HYDROGRAPHIC SURVEY H-8085 (FIELD NO. LJ-1253)

HARO STRAIT - WASHINGTON

REVIEW OF HYDROGRAPHIC SURVEY

REGISTRY NO. H-8085

Sketch showing positions
of strays

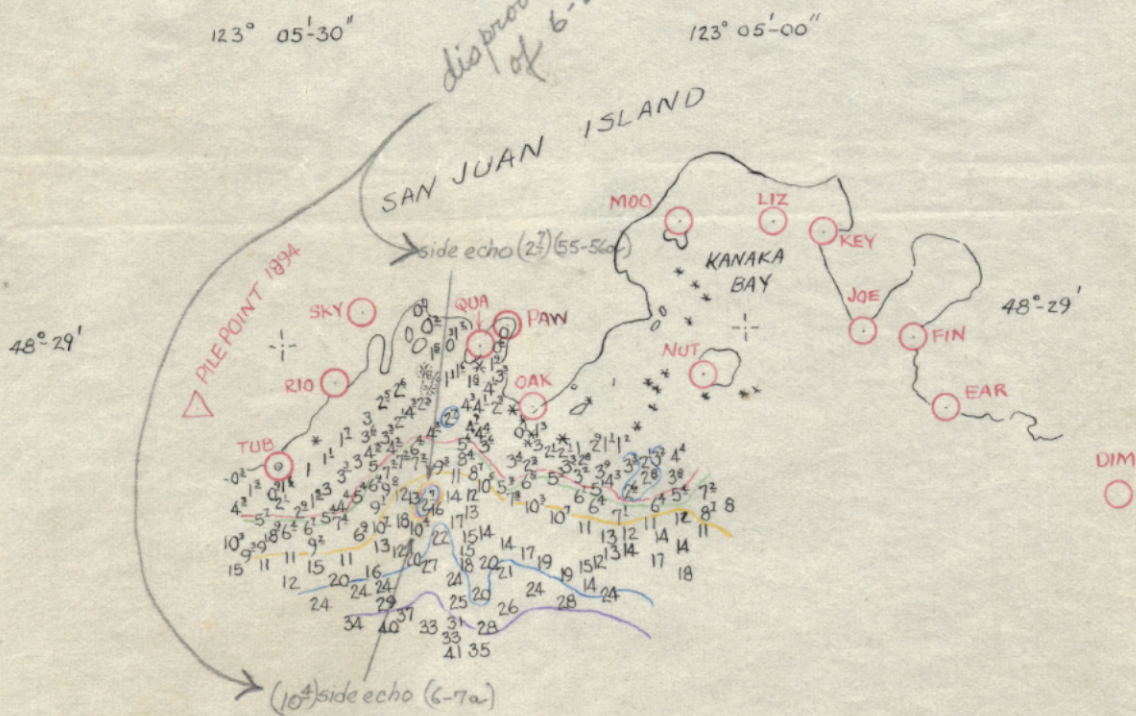
See Pcs { 1g
6g
9g
17g

disproved by development
of 6-23-54 (next page)

- (e) Additional development of 23 June 1954, consisting of closely spaced sounding lines, verified the 0.8-fm. sounding in lat. $48^{\circ}28.79'$, long. $123^{\circ}04.45'$, and disproved two apparent side-echo soundings of 2.7 and 10.4 fms. in lat. $48^{\circ}28.88'$, long. $123^{\circ}05.36'$. Tracings of the additional sounding lines are enclosed in the Descriptive Report.
